## SUMMARY OF COMMENTS

## Project Level PM Quantitative Hot-Spot Analysis – Project of Air Quality Concern Questionnaire

## Project Level PM Quantitative Hot-Spot Analysis – Consultation Document for Project of Air Quality Concern

## Project Level CO Hot-Spot Analysis Questionnaire

Figure 1. PM Links and Receptors Placement for Air Quality Modeling  
(Deer Valley Rd & I-17 TI)

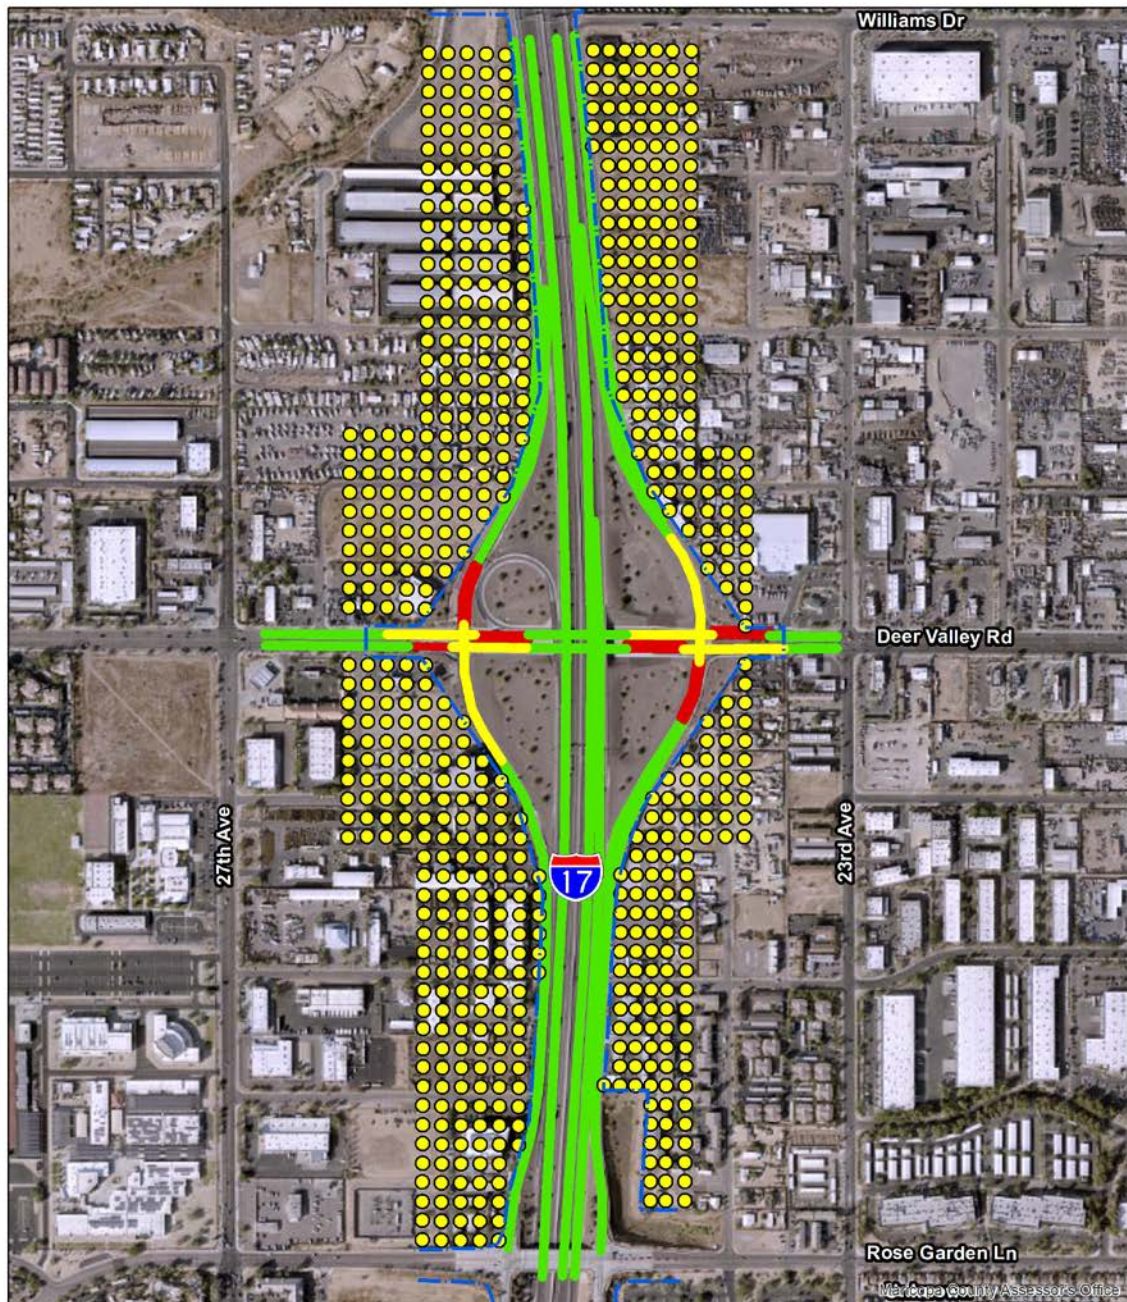
25	Lindsay Wickersham, EPA	F0316_PM10- Project Determination Consultation_20230213.pdf	c. Table 2, Step 5: It would be helpful to define variable names (for example, EMISEACT, SEASHR, and RECTABLE). Also, please explain the	Will provide AERMOD input files for review when ready.
26	Lindsay Wickersham, EPA	F0316_PM10- Project Determination Consultation_20230213.pdf	d. Table 2, Step 5, Receptors (RE Pathway): Please include receptors elsewhere along the project from 19th Avenue to Pinnacle Peak Road.	Pinnacle Peak Road intersections will be included for analysis. No actual construction work would occur from 19th Avenue. No
27	Lindsay Wickersham, EPA	F0316_PM10- Project Determination Consultation_20230213.pdf	e. Table 2, Step 5, Receptors (RE Pathway): Most receptors appear to be more than 25 meters apart. Please change the receptor spacing to be 25 meters apart if they are further than that. Furthermore, please verbally describe the spacing of the receptors as Figure 1 shows some receptors more densely packed than others.	In response to this comment, receptors locations have been revised to be 25 meter apart.

Figure 3. PM Monitoring Sites adjacent to the Project Area

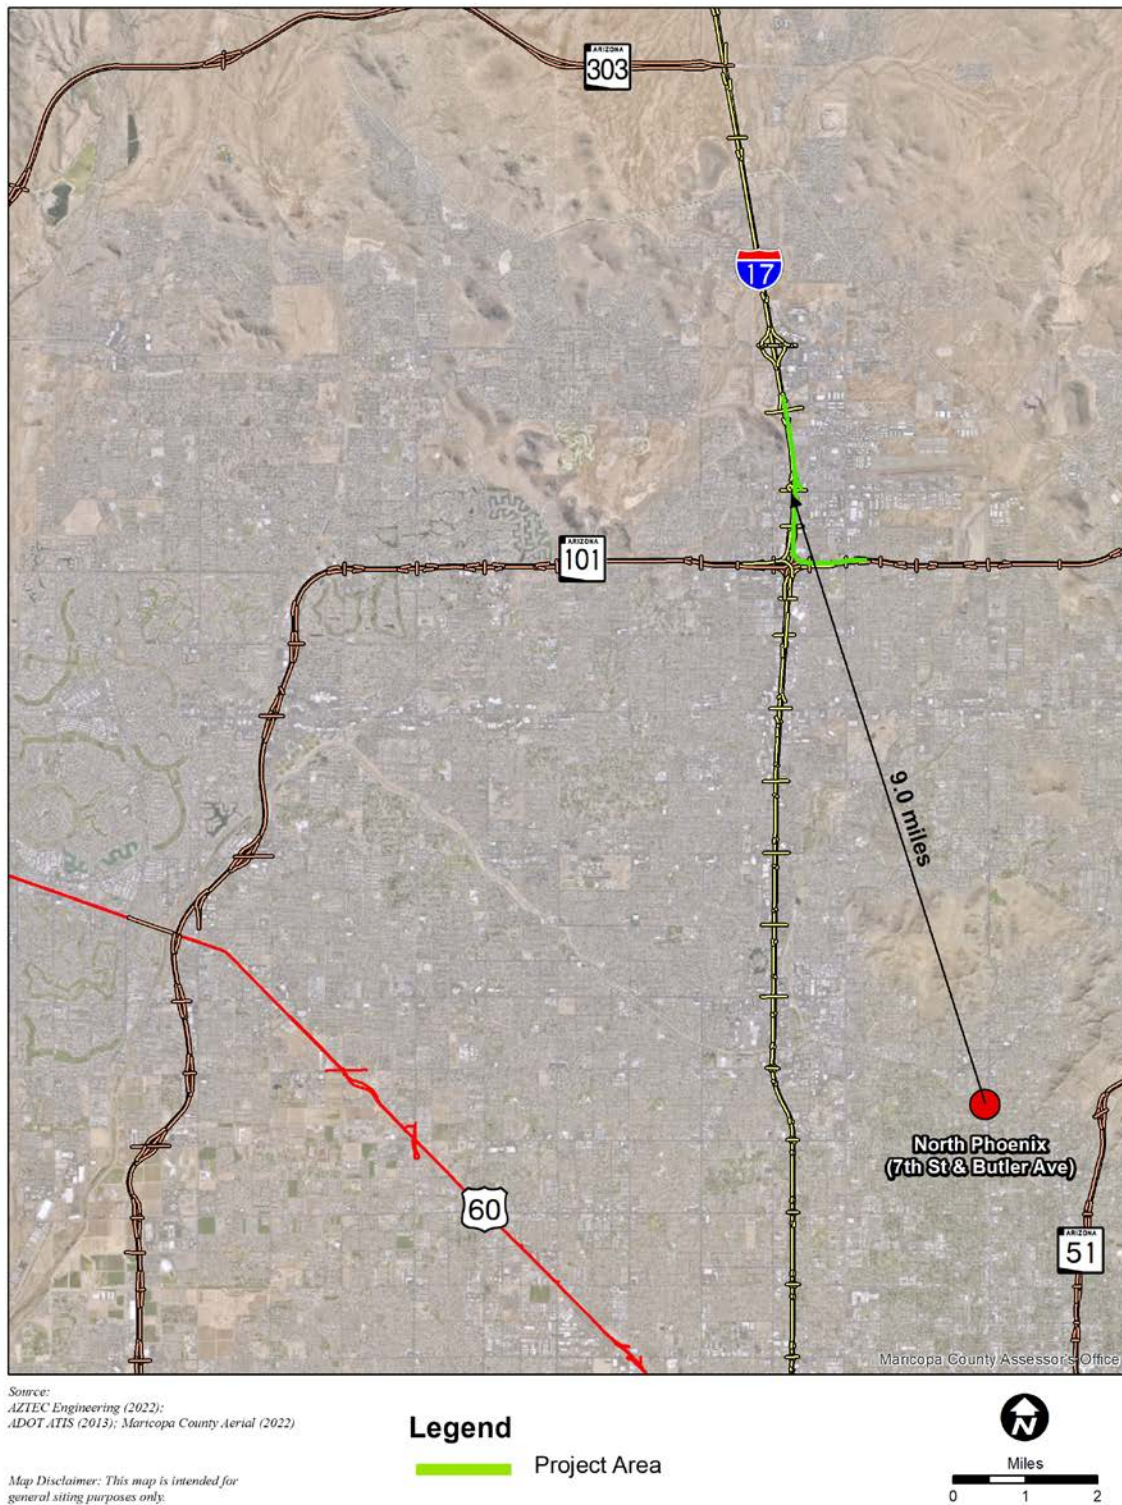
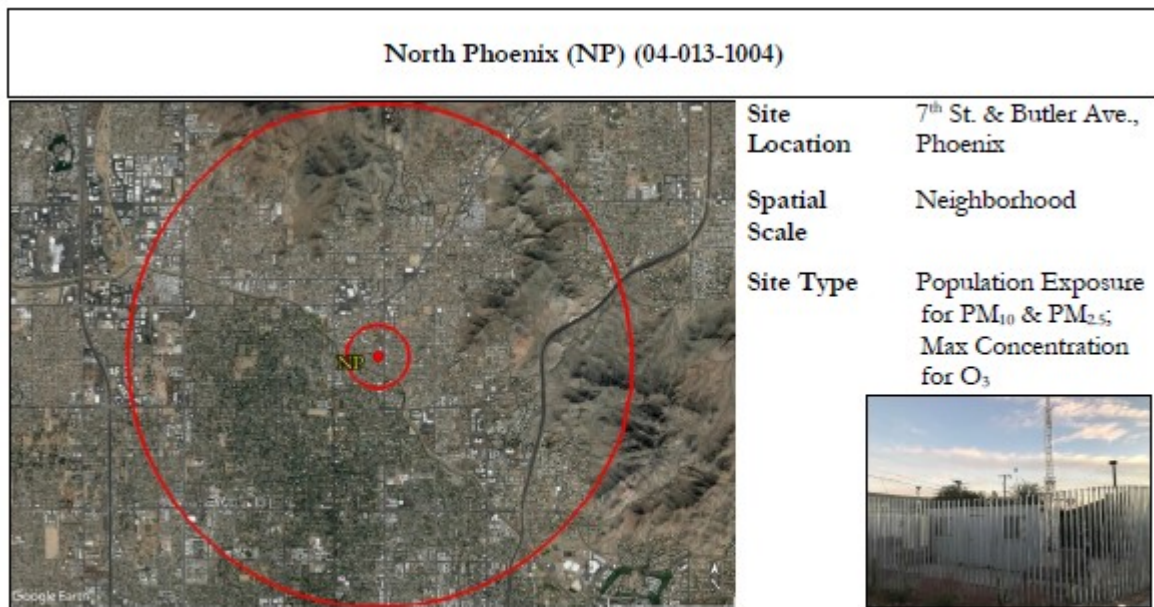
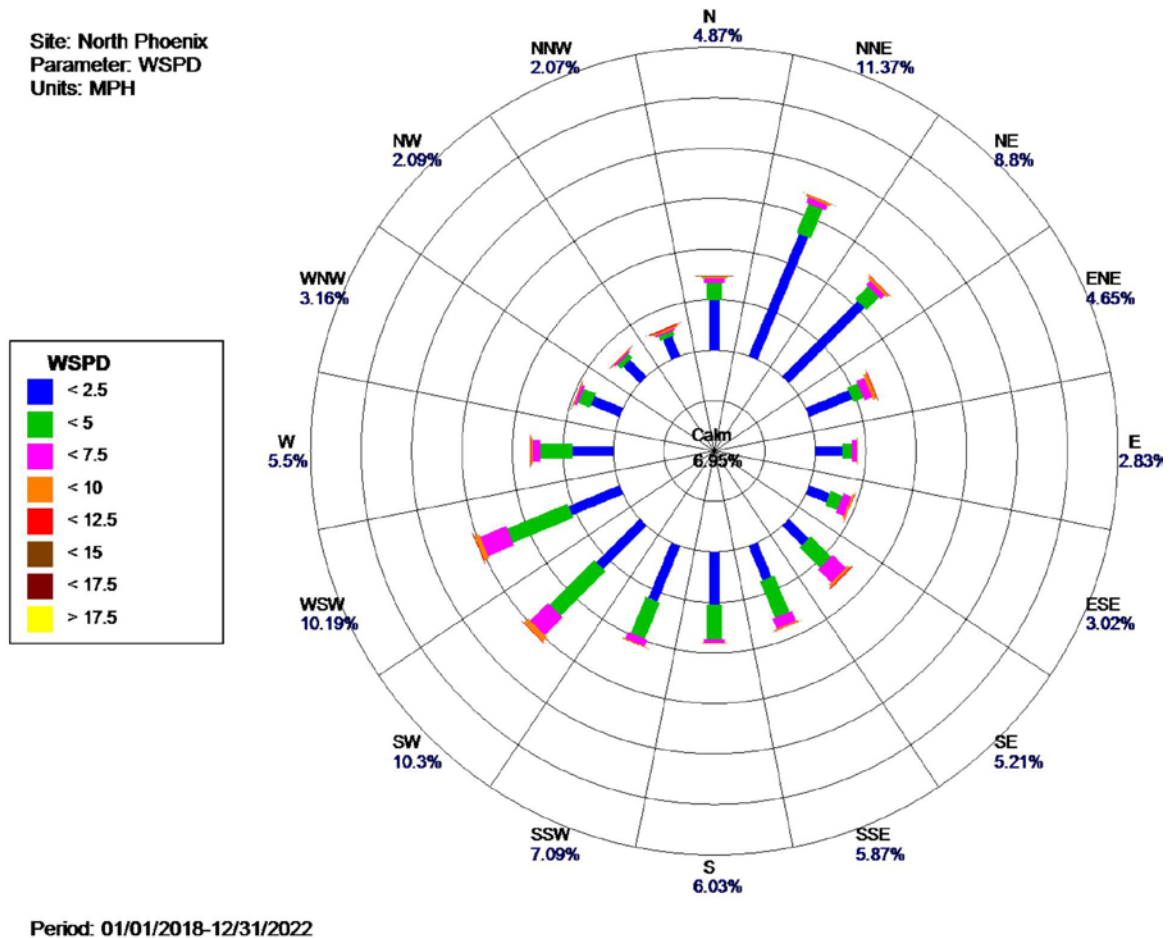
29	Lindsay Wickersham, EPA	F0316_PM10- Project Determination Consultation_20230213.pdf	g. Table 2, Step 6, Other Sources (Ambient Monitoring Data): More information should be provided to justify the choice of this monitor. How does this station represent the background conditions of the project area? Is this the closest monitor with similar land use to the project? Is this monitor frequently upwind of the project area? It would be helpful to look at a wind rose at the project area as well if that information is available. What is the height of this monitor? These are some questions which may help determine the choice of a monitor, which should be representative of background concentrations at the project area. See PM Hot-spot Guidance Section 8.3.1 for more details.	Will expand discussion.
30	Lindsay Wickersham, EPA	F0316_PM10- Project Determination Consultation_20230213.pdf	h. Table 2, Step 6, Other Sources (Ambient Monitoring Data): This row appears to describe the design concentration, even though that is in Step 7, as described earlier in the document. For the design concentration, the highest sixth-highest value among all receptors should be added to the fourth highest background monitor value (Section 9.3.4 of PM Hot-spot Guidance). This is similar to the explanation provided here, but it should be stated that this is the design concentration, not the background concentration.	This row only describes ambient monitoring data, especially the fourth highest background monitor value. The design concentration would be calculated in the later steps.

Figure 1. I-17 and Deer Valley Road TI Receptors and Roadway Links

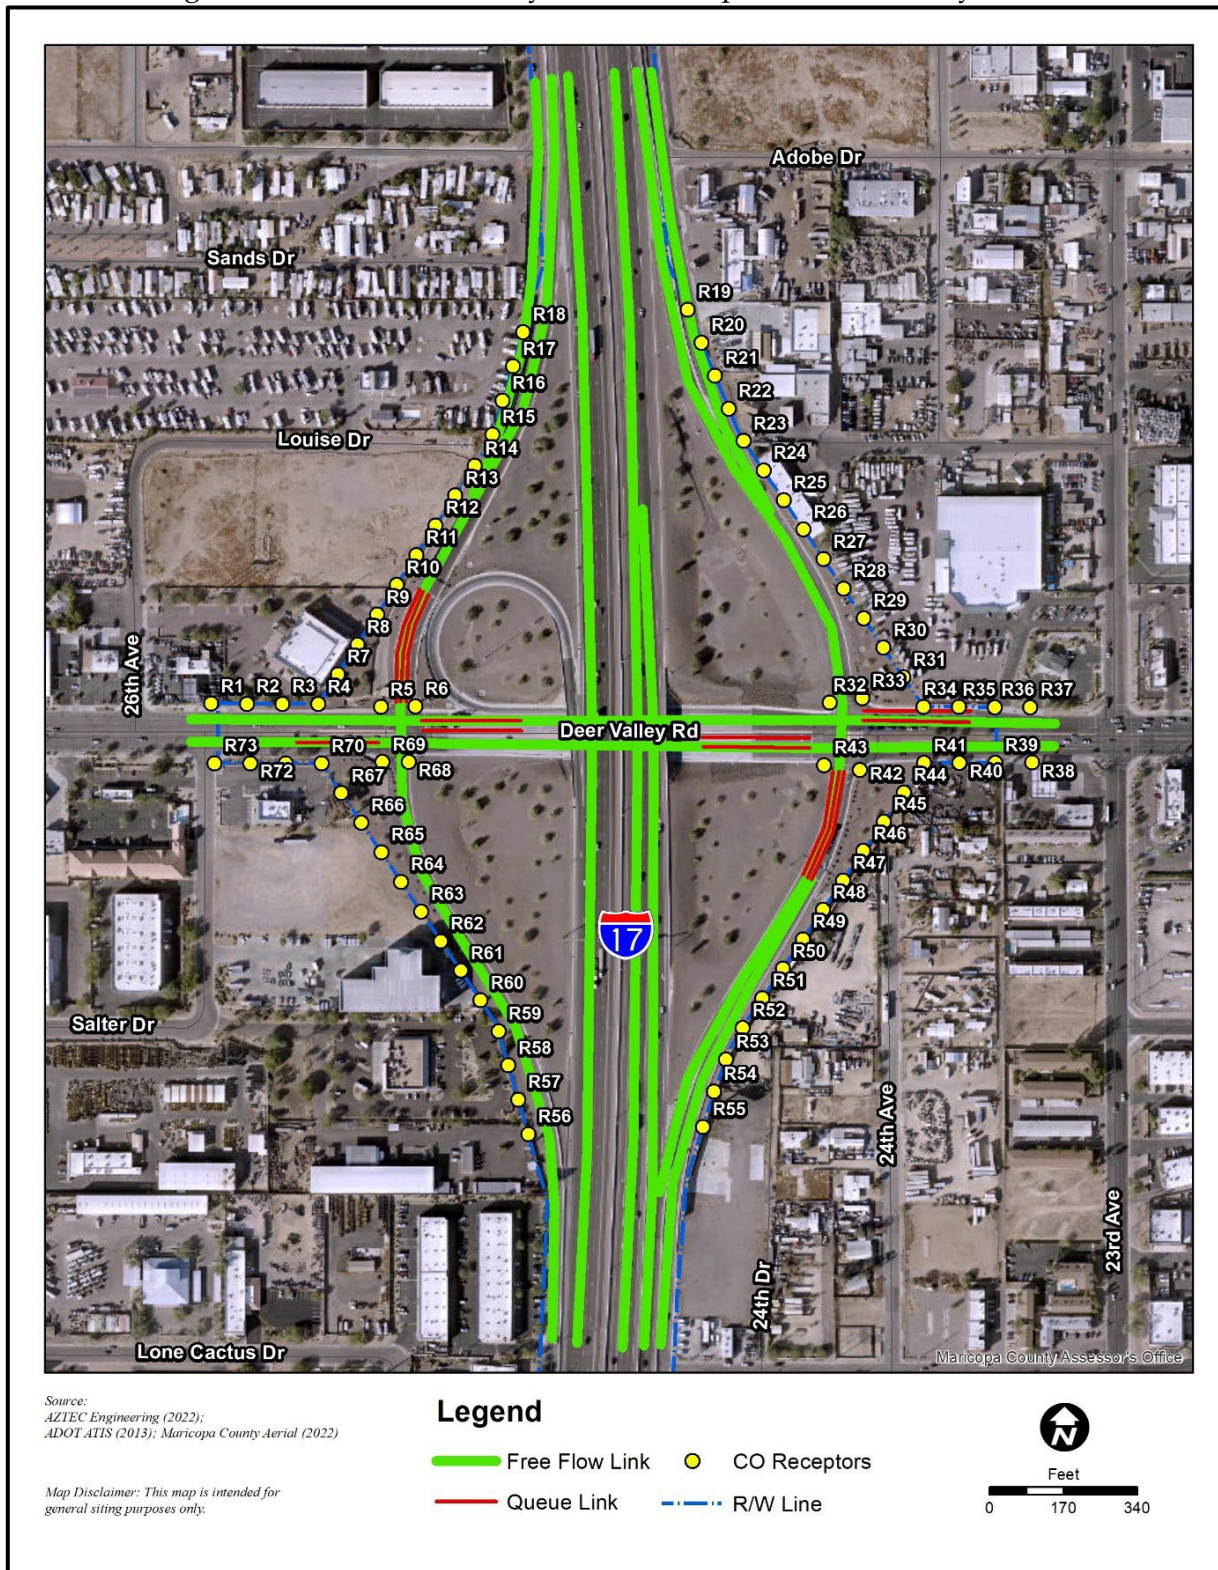
5	Lindsay Wickersham, EPA	F0316_Project-Level-CO-Modeling Consultation_20230213.pdf	b. For the row labeled "Receptor Locations," the descriptions provided in this row and on Page 13 are consistent with the 1992 Guideline for Modeling Carbon Monoxide from Roadway Intersections, but more detail should be provided on the receptor placement. For sidewalks, receptors should be located at least near intersection corners and at mid-block. Please explain in more detail how the receptor placement is consistent with Section 2.2 of the Guideline.	Receptors are located along the R/W line and at sidewalks at the four corner of the intersection, and mid block of approach and department links where the CO concentrations are likely to be the highest.
6	Lindsay Wickersham, EPA	F0316_Project-Level-CO-Modeling Consultation_20230213.pdf	c. For the row labeled "Traffic and Geometric Design," please provide the values that will be used for each of these parameters	Will provide for review when the input files are ready.

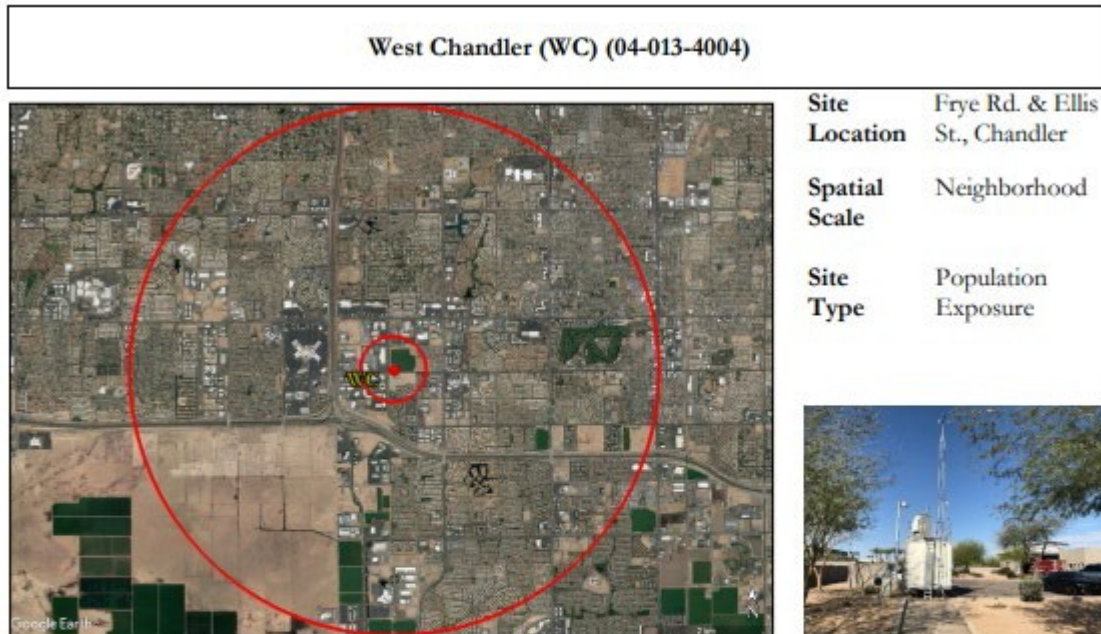
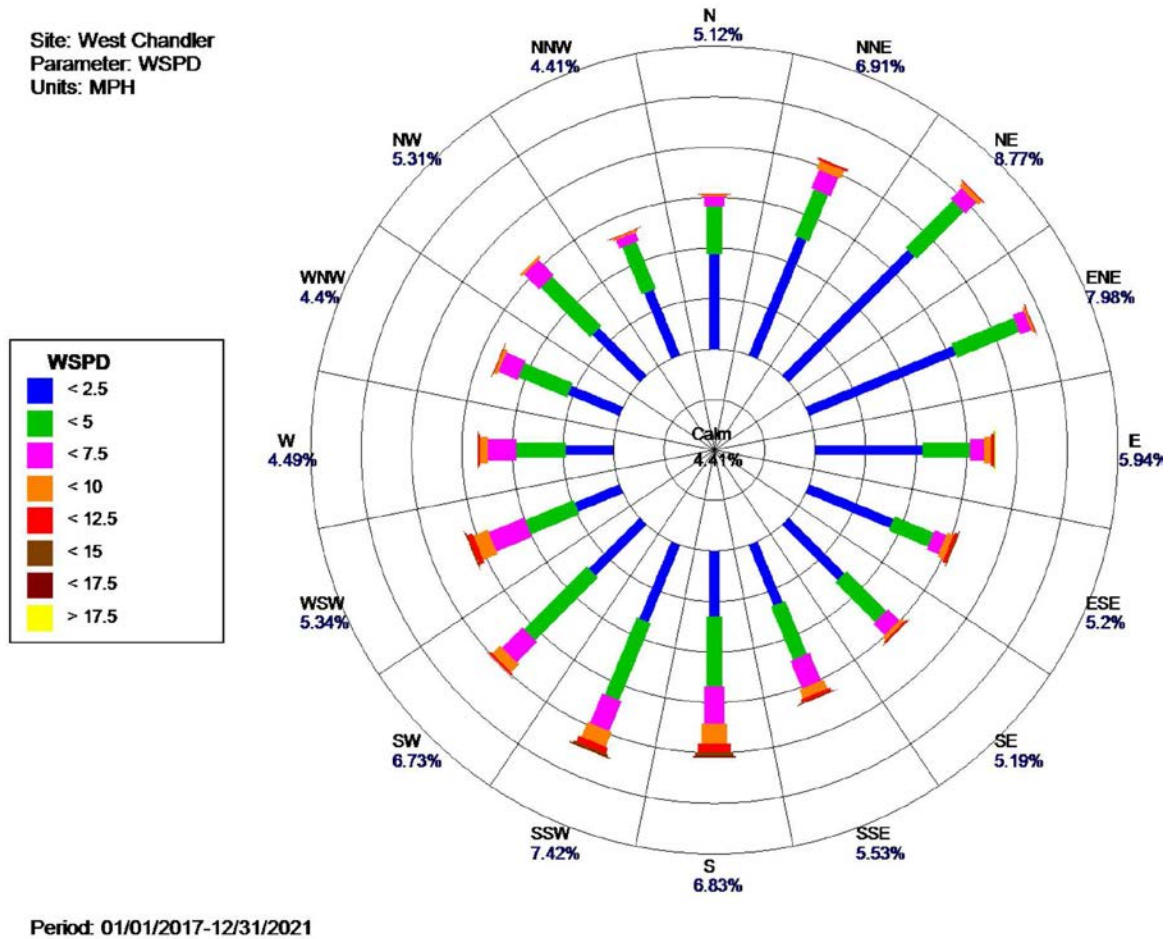
7	Lindsay Wickersham, EPA	F0316_Project-Level-CO-Modeling Consultation_20230213.pdf	d. For the row labeled "Meteorology," on page 11, please provide the values that will be used for each of these parameters	Will provide for review when the input files are ready.
8	Lindsay Wickersham, EPA	F0316_Project-Level-CO-Modeling Consultation_20230213.pdf	e. For the row labeled, "Persistence factor," please indicate whether the default or the local persistence factor will be used prior to modeling.	Will use default persistence factor of 0.7 because local measured 1-hour CO concentrations are not available.
9	Lindsay Wickersham, EPA	F0316_Project-Level-CO-Modeling Consultation_20230213.pdf	f. For the row labeled, "Background monitor," i. Please explain in more detail why the CO monitor at Frye Rd and Ellis St in West Chandler is chosen for the background concentration. This monitor should be representative of background concentrations at the project area.	There are no CO monitors within 12 miles from the project area. CO monitor at Frye Rd and Ellis St in West Chandler is chosen for the background concentration. The background concentration data of this monitor are representative for the project area because: 1. Similar characteristics between the monitor location and project area including density (developed area), mix of emission sources (two freeways nearby), land use (residential area & commercial, light industrial), terrain (relative flat), etc. 2. Distance of monitor from the project area. The West Chandler monitor is located in the fringe area away from central Phoenix, similar to the project area. 3. Wind patterns between the monitor and the project area. The West Chandler monitor does not show significant upwind patterns.
